Director Of Services,
Planning Department
South Dublin County Council
County Hall
Tallaght
Dublin 24.

APPLICATION RE: DEMOLITION OF AN EXISTING HOUSE; ANCILLARY OUTBUILDINGS AND THE CONSTRUCTION OF 1 TWO TO FOUR STOREY BUILDING ACCOMMODATING 19 APARTMENTS COMPRISED OF 6 ONE BEDROOM APARTMENTS AND 13 TWO BEDROOM APARTMENTS; VEHICULAR ACCESS TO THE PROPOSED DEVELOPMENT WILL BE VIA LUCAN ROAD WITH TRAFFIC CALMING MEASURES ONTO LUCAN ROAD; 11 CAR PARKING SPACES AND 20 BICYCLE PARKING SPACES AND ANCILLARY SERVICES INCLUDING A DETACHED WATER STORAGE TANK AND BIN STORE HOUSING ALL ON A SITE OF 0.1925 HECTARES. (REG. REF: SD22A/0324)

Extract from contiguous elevation which shows the relationship between the proposed development and adjoining residential properties

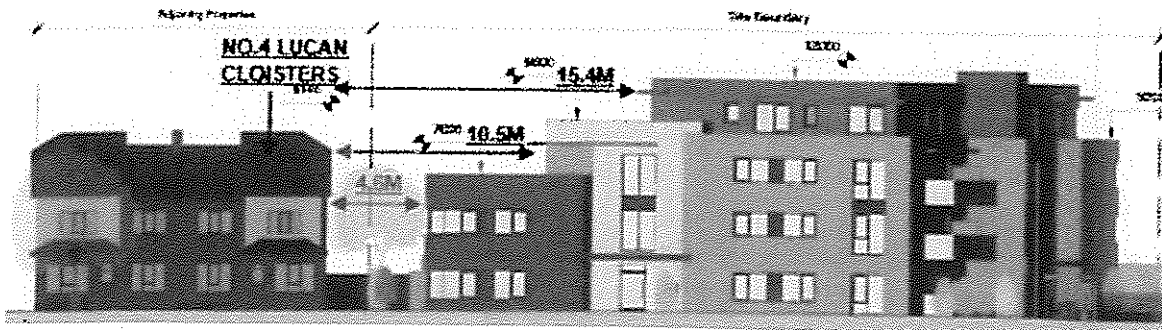
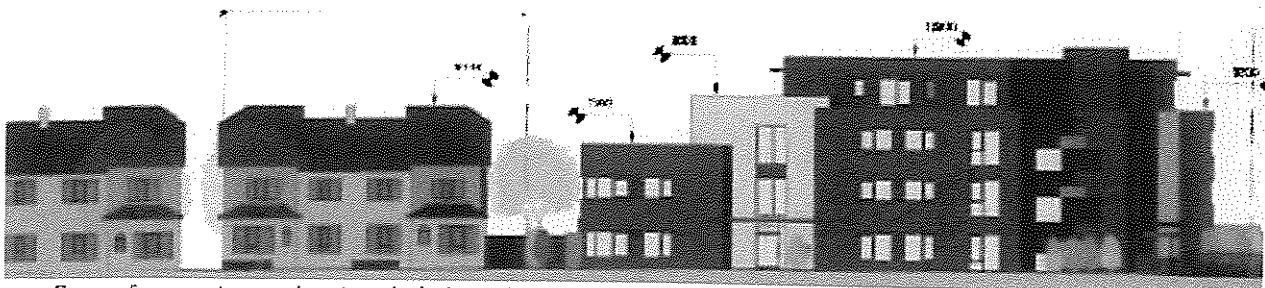
All planning in Ireland is now subject to National and Regional Strategies and thereafter statutory development plans for a county area. That said it comes with many riders, the most important one being that the protection of character areas is central to the primary target of upping densities in cities and towns where good transport links are available, along with jobs and close links to retail and community services. In the present instance we would submit that the proposed development is not one that can rely on the density objectives of the national or regional plans, as it is taking place in a small outer suburban area distant from a frequent public transport service.

The South Dublin Development Plan 2022-2028 has taken special care to provide a template to assist the Planning Authority in achieving increased density, but in the context of Ministerial guidelines. What is clear from the planning application submitted is that the applicants paid no heed to the current statutory development plan for the area, i.e. South Dublin Development Plan 2022-2028, and as such ignored the many objectives and polices of the plan which deals with density, height, and traffic. The excellent document prepared by O'Mahoney Pike has been ignored by the applicants. We would submit that strict compliance to that document would have resulted - notwithstanding the serious traffic issues arising from the proposed development - in a reduction in the massing and overbearing nature of the development on the receiving environment.
